**TOWN OF CANMORE
RECORD OF WRITTEN SUBMISSIONS
Special Meeting**

Spring Creek Mountain Village Area Redevelopment Plan Amendments Bylaw 2021-22 and Land Use Bylaw Amendments Bylaw 2021-23

Figure 3
A lake or wetland buffer on glacial till, comprised of a vegetated filter strip (VFS), and setback for shallow groundwater.

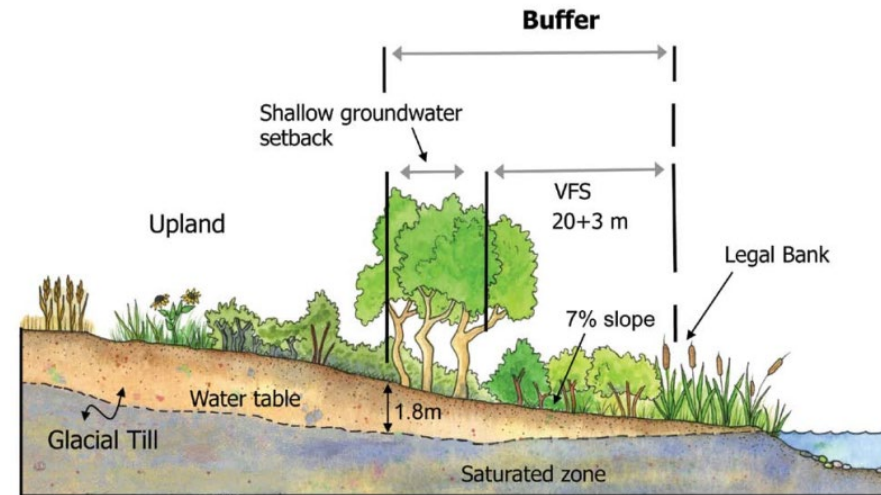
“Top of Bank” should be replaced with “Legal Bank” as identified in the “Stepping Back from the Water” document adopted by the Town of Canmore.

Structural decks should not be permitted within the 15m setback of the Legal Bank.

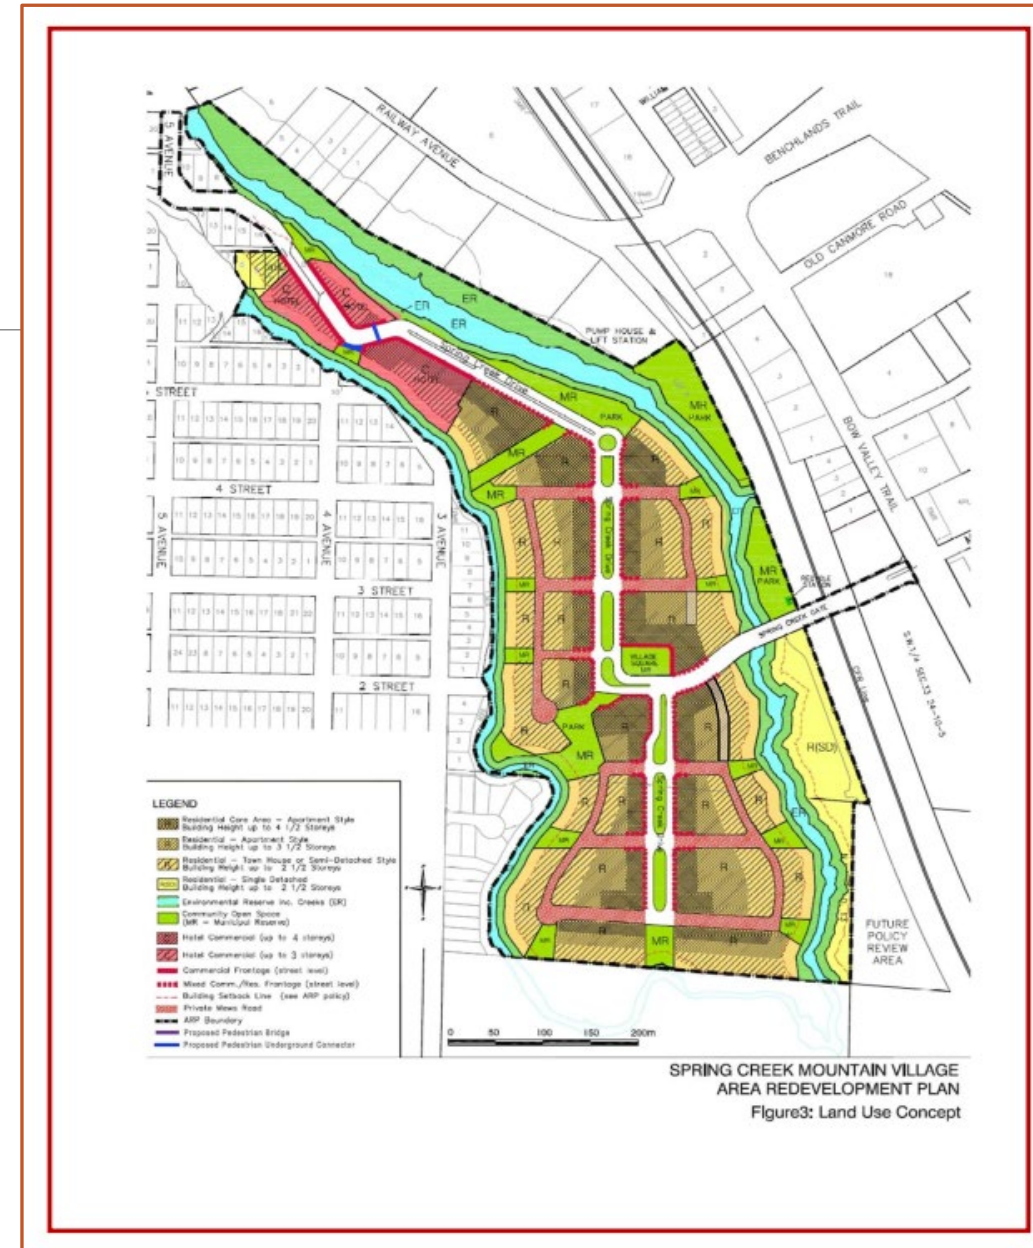
17. Section 14.19.4.3 Building Heights Zone C

Zone C - 12 M adjacent to R1, expected to jump to 14.5 M to 16 M with finished grades.

“Finish Grade” changed to “Existing Grade at the Existing Curb”.

Building should be required to terrace down to 9.5 m to Spring Creek and Policeman’s Creek and adjacent R1 communities consistent with the ARP elsewhere.

Figure 1

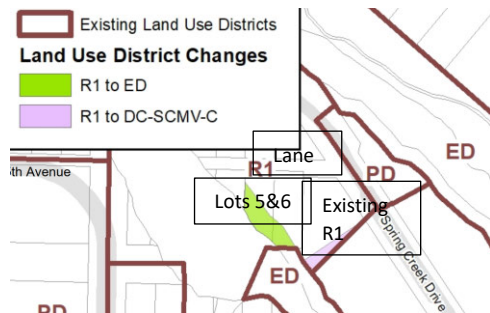
This map as noted Appendix C, SCMV Red Lined document if it remains as R1 Zoning, I have no issue as presented.

The red-line document and the BYLAW however refers to reconfiguration of lots 5 and 6. What does that mean? Does it mean reconfigured into DC-SCMV-C commercial. This is not clear and can be interpreted many different ways. It provides for a lot of wiggle room to the interpretation in the future

At this time, it is also requested the lane way (shown in Figure 1) be retained by the town of Canmore. For the current and long term use by the four (4) existing residences. That it is retain as a laneway only and not be included as access to the SPA and underground parking. That the lane is also not zoned as a main residential frontage access, for SCMV R1 or commercial development. It is also requested that extra land owned by town at the entrance to the lane also be retained. This provides for residential parking in this area.

FIGURE 2

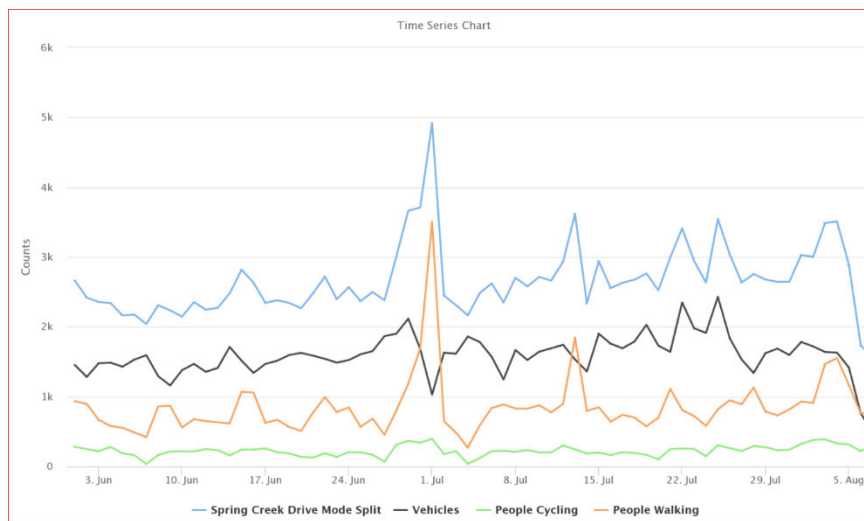
Data obtained from the 2014 traffic counter (I have to pay for the town data now), shows vehicles at 2,300 see figure #2 below. A transportation study is required as part of any new proposed changes to the ARP. If the number of vehicles exceeds or is projected to generate greater than 3,000 vehicles per day (vpd.), (ARP 4.5.10) a change in road design and/or reduction in density is to occur. The 3,000 vpd. number for Spring Creek Drive (formally 5th Ave) was based on a **FINN transportation study that stated if vehicle numbers exceeded the 3,000 vpd., it would impact the traffic flow in the down town core as well as egress and access to those areas. Which is a concern for emergency vehicle response time, not to mention increase traffic congestion on main street and impacts for every intersection in the area.**

congestion and evacuation in the event of a flood or a fire. **Nor should the 3,000 vpd be averaged over 8 months as identified in BYLAW 14.27.4.12. This then allows for any number of vehicles on a daily basis, forever.**

FIGURE #2 – NOTE THE BLACK LINE INDICATES VEHICLE USE in 2014. Buildout at that time was around 30 to 40%. VPD reached 2500, vehicle use on

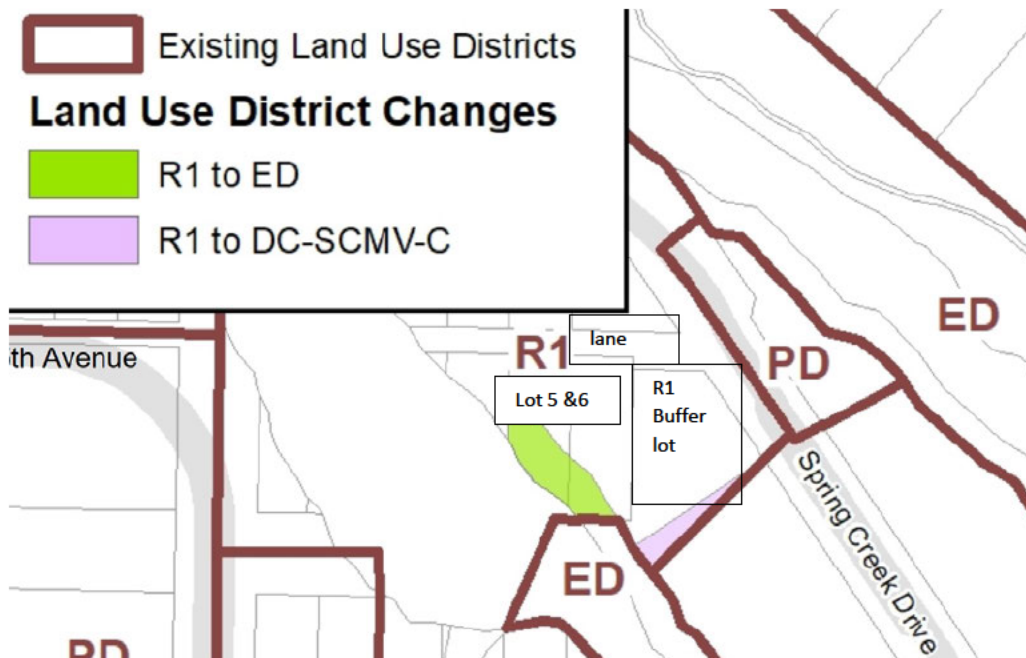
Figure 2, below, lots 5 and 6 are part of an existing R1 neighbourhood. The R1 in the box which is currently part of SCMV is the buffer lot between the commercial property and current R1 adjacent community. Maintaining this set back is **consistent with MDP 4.2.24** and reference document “**Stepping Back from the Water**”. I would argue that the riparian adjacent to these lots are important and of value in this consideration. SCMV 4.3.3 Creek Protection, states these creeks are high priority for sensitive fish habitat.

I live beside this lot and have been told by the Town of Canmore planning department that I would be required to be within the by-law if I was to re-develop. So I ask why should lots 5 and 6 be any different. I would argue that they should **NOT** be incorporated in the ARP with the same setbacks that are currently approved at 15 m. there are no constraints to lots 5 & 6 for R1 development. For example, structural decks would not be allowed with the 5m set back.

Figure 1. Maximum Building Heights

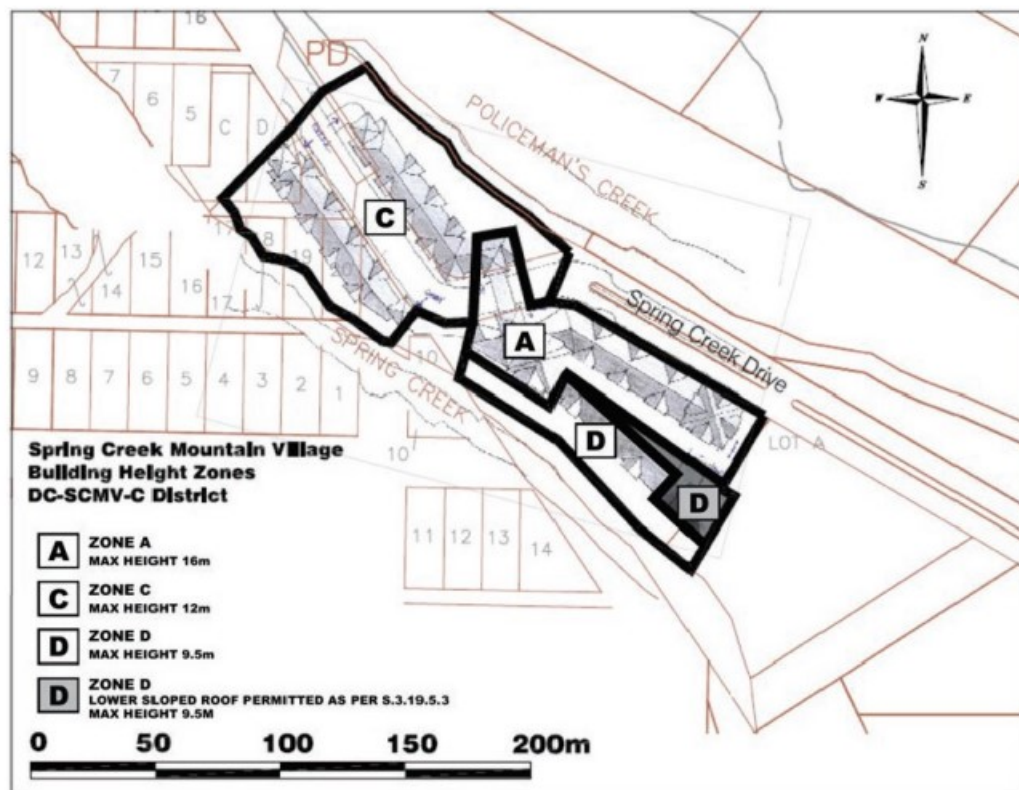
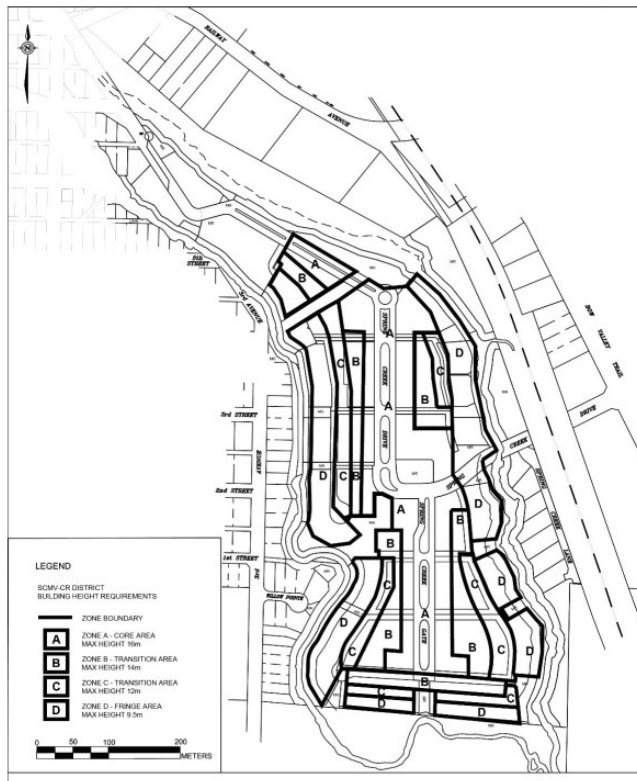
See figure 14.19.5.8 and Figure 1, 14.27.4.9. from the Town of Canmore documentation. See attached figures below.

Grades should be set at the current grades on site measured at the existing road / curb edge. Building adjacent to Spring Creek and R1 Residential lots should both be set at 9.5 m and terrace up to 16 m to meet the Malcolm. The additional 50 rooms should not be approved if this cannot be meet.
